Southern Nuclear
Operating Company, Inc.
42 Inverness Center Parkway
Birmingham, Alabama 35242

ND-17-0271
10 CFR 50.90
10 CFR 52.63

Southern Nuclear Operating Company
Vogtle Electric Generating Plant Units 3 and 4
Request for License Amendment and Exemption:
Addition of In-containment Refueling Water Storage Tank (IRWST)
Lower Narrow Range Level Instrumentation (LAR-16-032)

Revise UFSAR Figure 7.2-1 (Sheet 2), "Functional Diagram Reactor Trip Functions," as shown below:

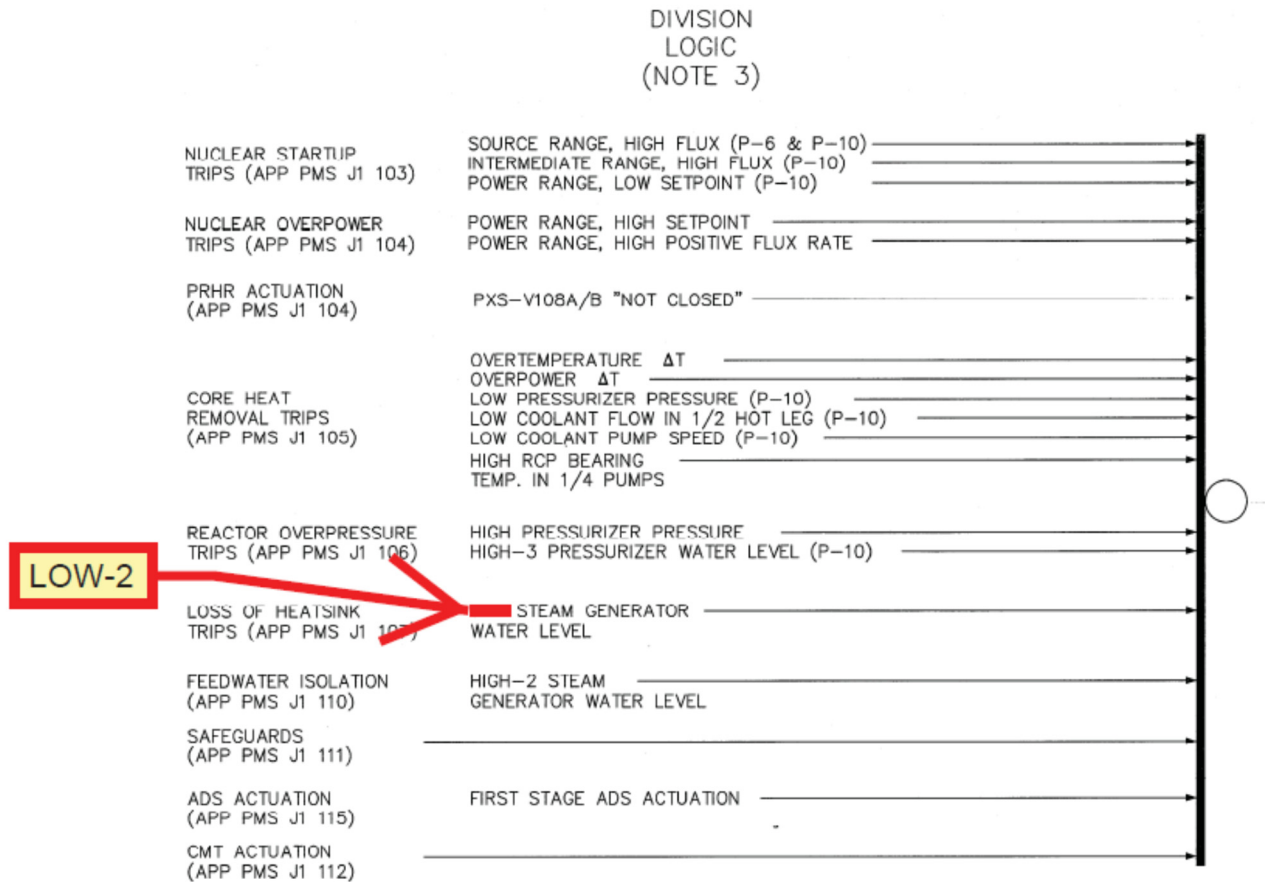
- f. Figure 7.2-1 (Sheet 2) is revised to change the name of the existing Low steam generator water level reactor trip to Low-2 steam generator water level.
- g. Figure 7.2-1 (Sheet 7) is revised to add the new P-9 permissive and interlock to the existing Low steam generator water level (narrow range) reactor trip including the low steam generator level PRHR actuation block control (as shown on UFSAR Figure 7.2-1 (Sheets 2 and 7)), and to change the name to Low-2 steam generator water level (narrow range) reactor trip.
- h. Section 7A.8 is added to address changes required to WCAP-16675 (Proprietary and Non-Proprietary), AP1000 Protection and Safety Monitoring System Architecture Technical Report, as follows:

Revise UFSAR Figure 7.2-1 (Sheet 7), “Functional Diagram Loss of Heat Sink Protection,” as shown below:

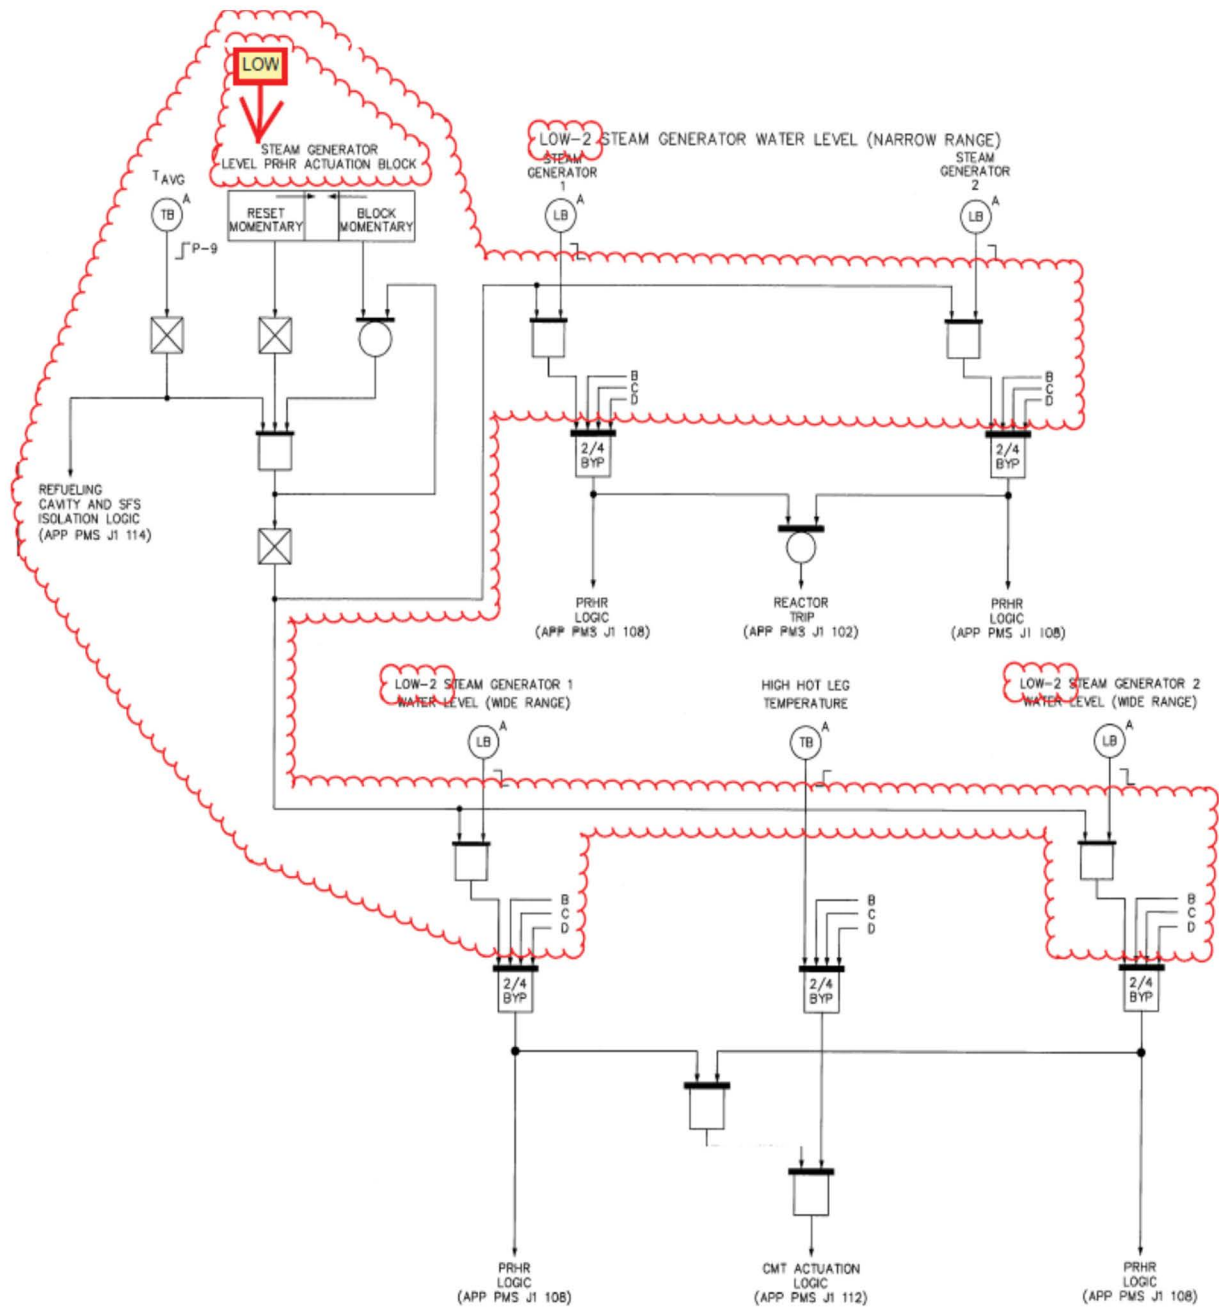
- d. Figure 7.2-1 (Sheet 7) is revised to add the new P-9 permissive and interlock to the existing PRHR heat exchanger actuation logic from a Low steam generator water level (narrow range) signal coincident with a startup feedwater flow signal in either steam generator 1 or 2 (as shown on UFSAR Figure 7.2-1 (Sheets 7 and 8)), and to change the name to Low-2 steam generator water level (narrow range).

- e. Figure 7.2-1 (Sheet 7) is revised to add the new P-9 permissive and interlock from a Low steam generator water level (narrow range) signal in either steam generator 1 or 2 (as shown on UFSAR Figure 7.2-1 (Sheets 7 and 8)), and to change the name to Low-2 steam generator water level (narrow range).

- f. Figure 7.2-1 (Sheet 7) is revised to add the new P-9 permissive and interlock from either a Low steam generator 1 water level (wide range) signal or a Low steam generator 2 water level (wide range) signal and to change the names to Low-2 steam generator 1 water level (wide range) and Low-2 steam generator 2 water level (wide range).

- g. Figure 7.2-1 (Sheet 7) is revised to add the new P-9 permissive and interlock to the existing Low steam generator 1 water level (wide range) signal and a Low steam generator 2 water level (wide range) signals and to change the name to Low-2 steam generator 1 water level (wide range) and Low-2 steam generator water level (wide range).

Revise UFSAR Figure 7.2-1 (Sheet 8), “Functional Diagram Loss of Heat Sink Protection,” as shown below:

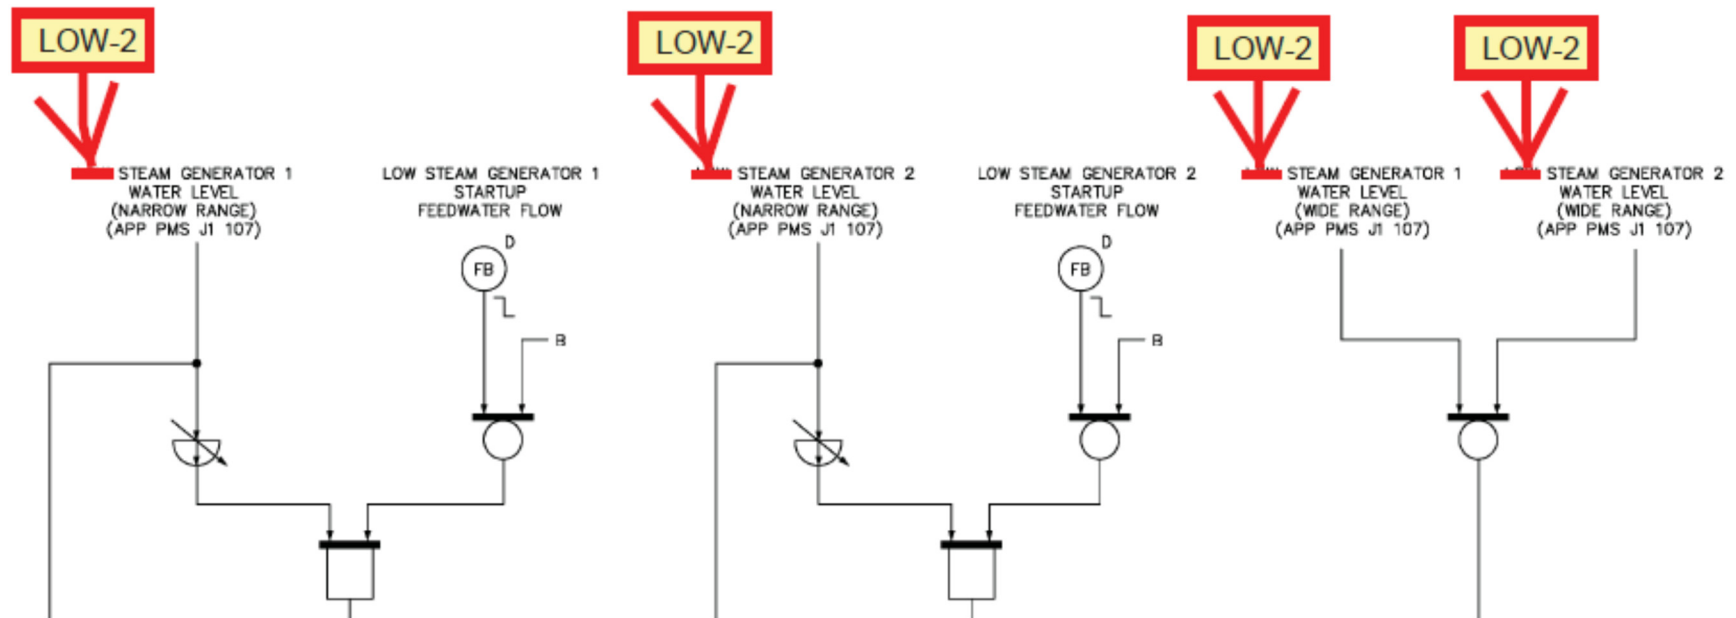
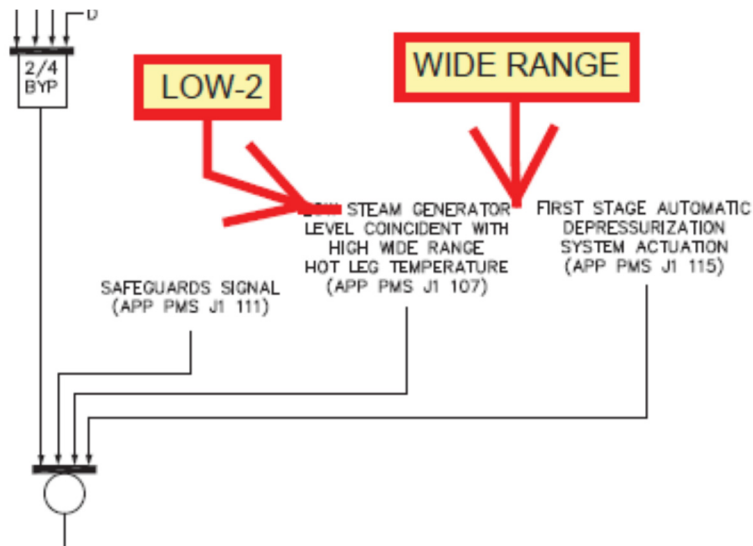
- h. Figure 7.2-1 (Sheet 8) is revised to change the name of the existing Low steam generator 1 water level (narrow range), Low steam generator 2 water level (narrow range), Low steam generator 1 water level (wide range), and Low steam generator 2 water level (wide range) to Low-2 steam generator 1 water level (narrow range), Low-2 steam generator 2 water level (narrow range), Low-2 steam generator 1 water level (wide range), and Low-2 steam generator 2 water level (wide range).

Revise UFSAR Figure 7.2-1 (Sheet 12), “Functional Diagram Loss of Heat Sink Protection,” as shown below:

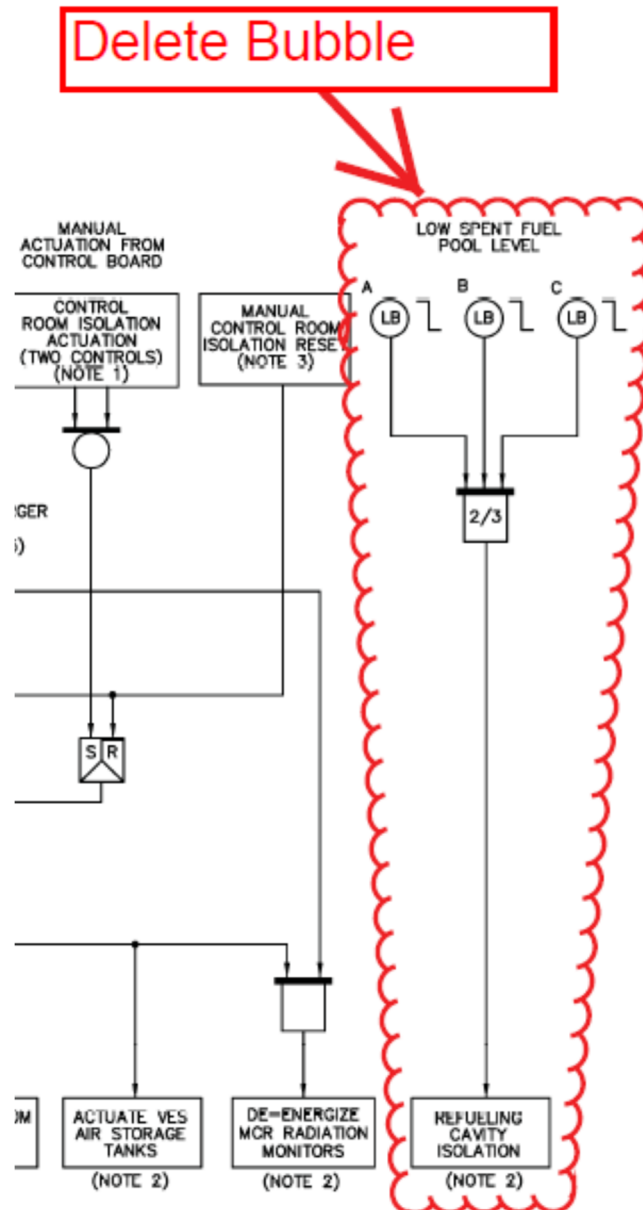
- i. Figure 7.2-1 (Sheet 12) is revised to change the name of the existing Low steam generator level to Low-2 steam generator wide range level.
- j. Subsection 7.3.1.2.3 is revised to add manual block and automatic unblock for the existing Low wide range steam generator level signal for CMT actuation logic below and above P-9 permissive and interlock, respectively, and to change the name to Low-2 in one place, to rename wide range level as wide range water level in one place, and to add reference to UFSAR Figure 7.2-1, Sheet 7, for development of the new P-9 permissive and interlock.

Revise UFSAR Figure 7.2-1 (Sheet 13), "Functional Diagram Containment and Other Protection," as shown below:

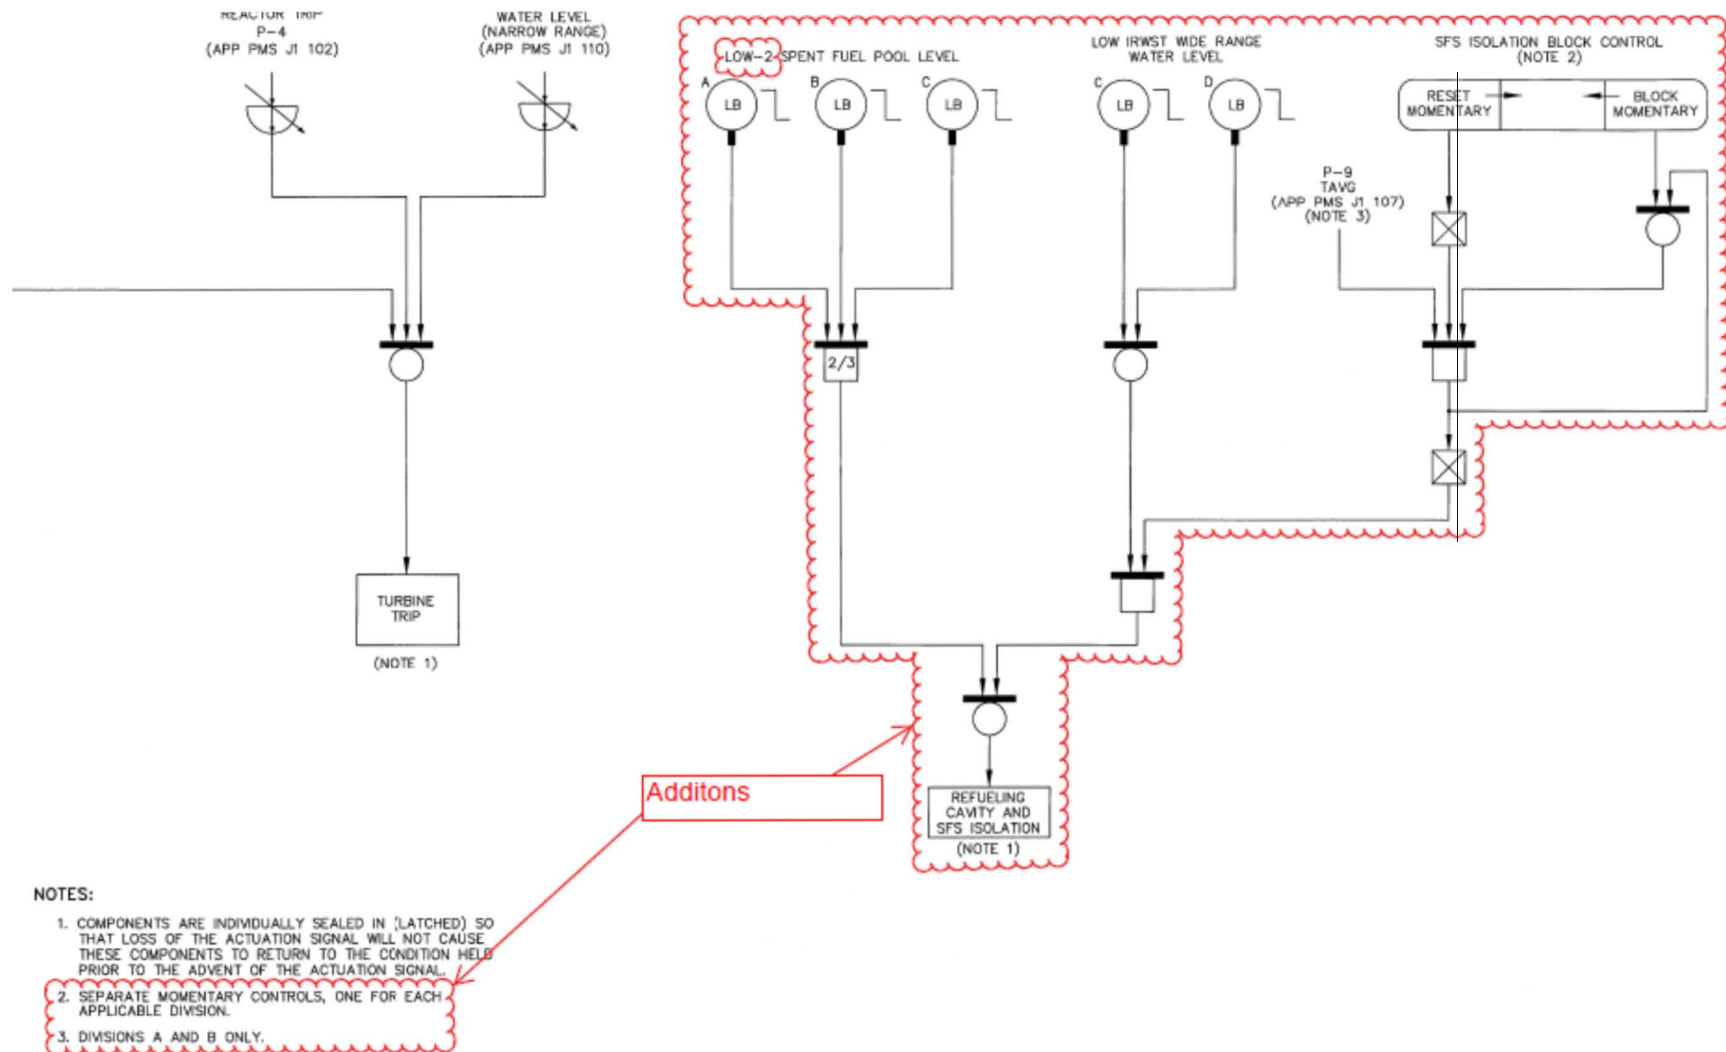
- g. Figure 7.2-1 (Sheet 13) is revised to delete the logic for 2 of 3 divisions of Low spent fuel pool level for refueling cavity isolation. This logic is relocated and modified by the changes to refueling cavity and SFS isolation logic shown on UFSAR Figure 7.2-1 (Sheet 14), as described below.

Revise UFSAR Figure 7.2-1 (Sheet 14), "Functional Diagram Turbine Trip and Refueling Cavity and SFS Isolation," as shown below:

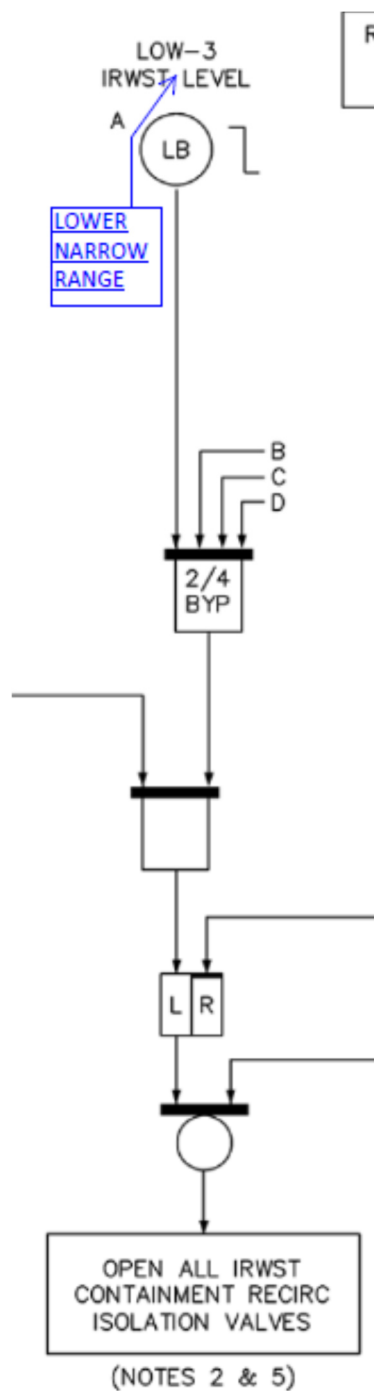
- h. Figure 7.2-1 (Sheet 14) is revised to add the new P-9 permissive and interlock from division A and B only (as shown on UFSAR Figure 7.2-1 (Sheet 7)) coincident with divisions C and D of the new Low IRWST wide range level (one-out-of-two logic), for refueling cavity and SFS isolation logic. In addition, Note 3 is added for the new P-9 permissive and interlock stating divisions A and B only, and Note 2 is added for the SFS isolation block control stating that there are separate momentary controls, one for each division. The logic for 2 of 3 divisions of Low spent fuel pool level for refueling cavity and SFS isolation is relocated from UFSAR Figure 7.2-1 (Sheet 13), and changed to Low-2 spent fuel pool level. Finally, the title is changed to Functional Diagram Turbine Trip and Refueling Cavity and SFS Isolation.
